Generation Deactivation Quick Fix Manual 14D Compliance Changes

PJM Interconnection

Manual 14-D, Generator Operational Requirements Revisions

M14D, Generation Deactivation Process Flow

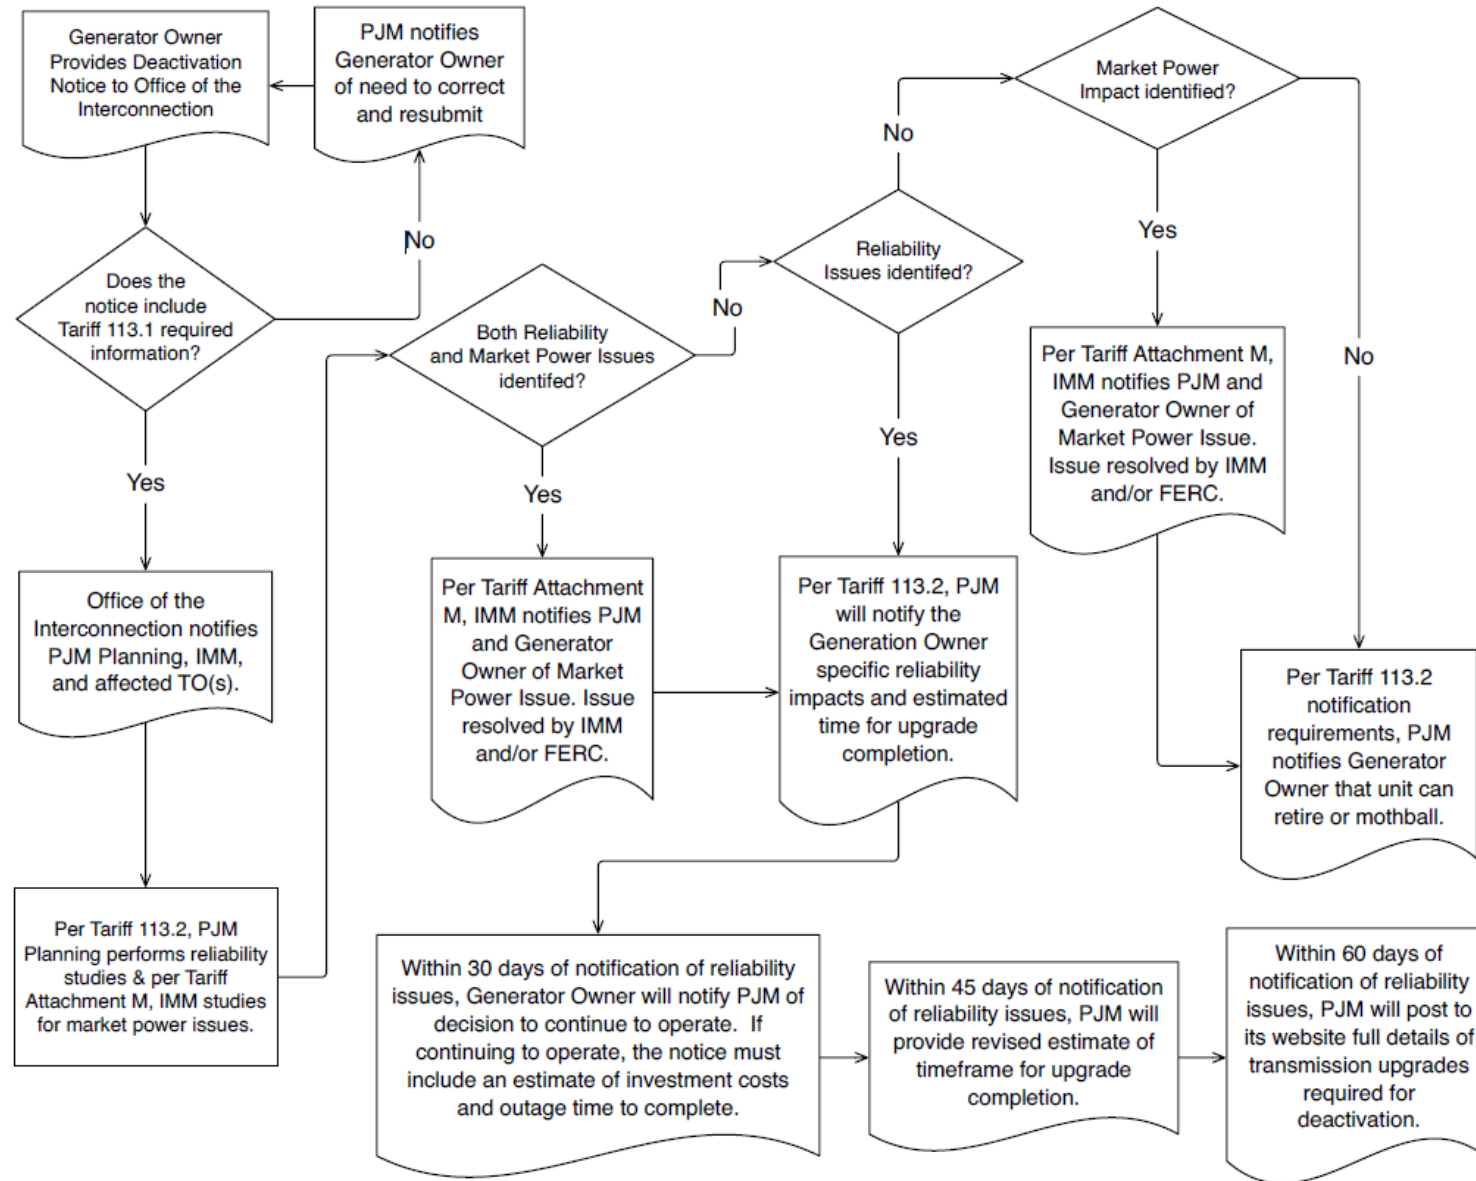
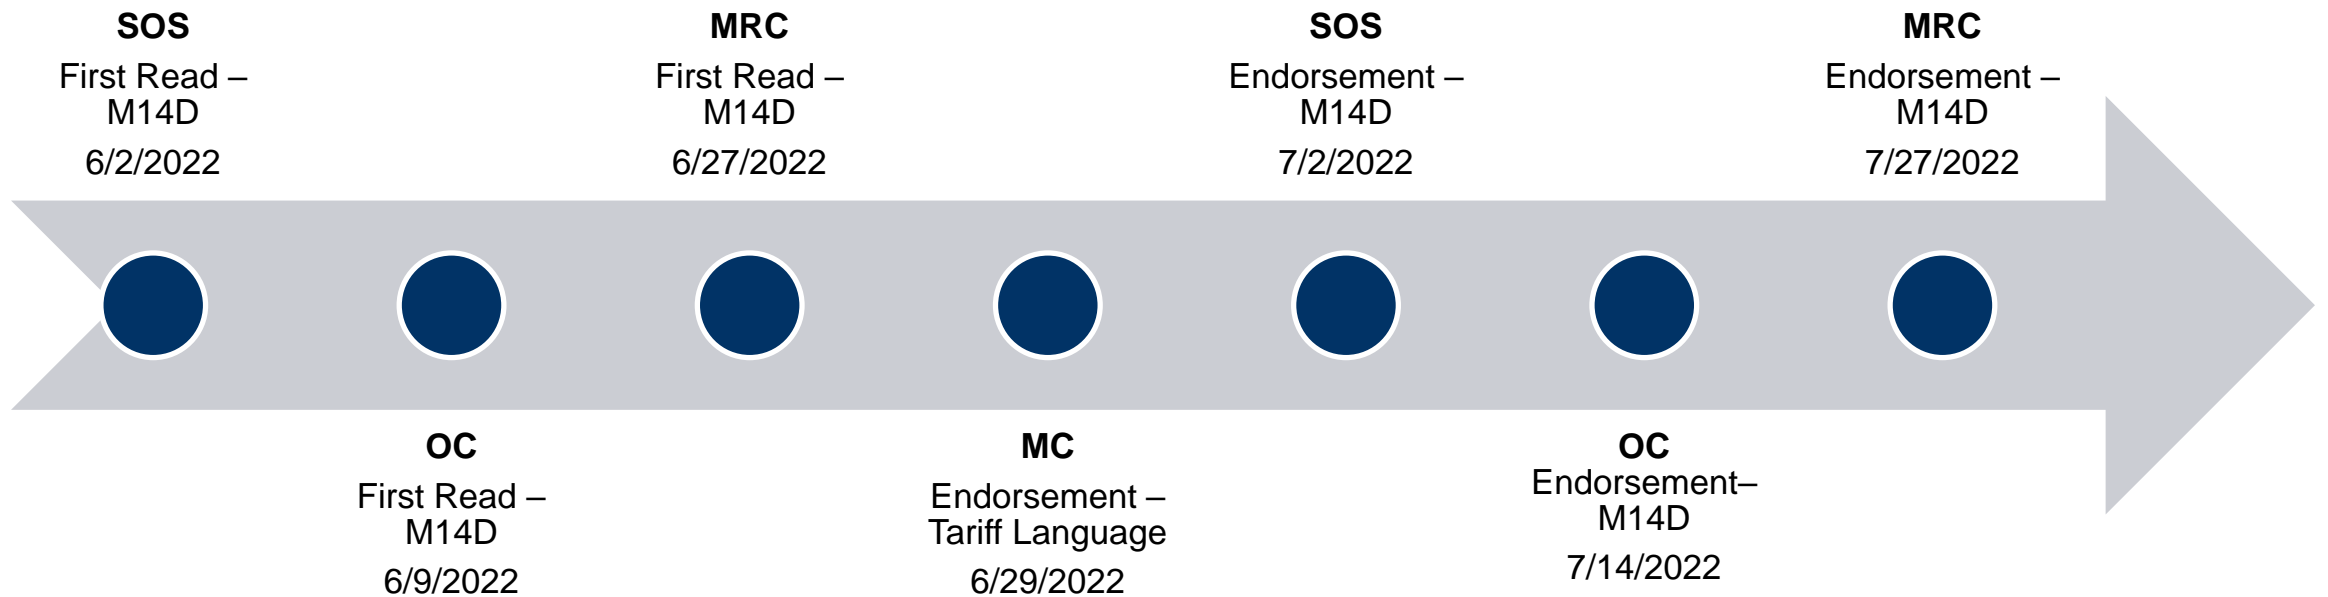
- Consistent with the schedule set forth in this section 9.1.3, PJM will notify the Generation Owner, or its designated agent, ~~within 30 days of the deactivation request~~ if a reliability issue has been identified. This notice will include the specific reliability impact resulting from the proposed deactivation of the unit, as well as an initial estimate of the period of time it will take to complete the Transmission upgrades necessary to alleviate reliability impact.

- Within ~~60~~ 30 days of ~~Deactivation~~ PJM's notification of reliability issues ~~Notice,~~ Generation Owner, or designated agent, will notify PJM of decision to continue to operate. If continuing to operate, the notice must include an estimate of investment costs and outage time to complete.

- Within ~~75~~ 45 days of PJM's notification of reliability issues ~~the original deactivation request,~~ PJM will provide a revised ~~n updated~~ estimate of the ~~period~~ timeframe for completion of ~~time it will take to complete the T~~ transmission upgrades necessary to alleviate reliability impact.

- Within ~~90~~ 60 days of PJM's notification of reliability issues ~~initial deactivation request,~~ PJM will inform the Generation Owner, or designated agent, and post on its web site full details of the transmission upgrades that will be required in order to allow the unit to deactivate.
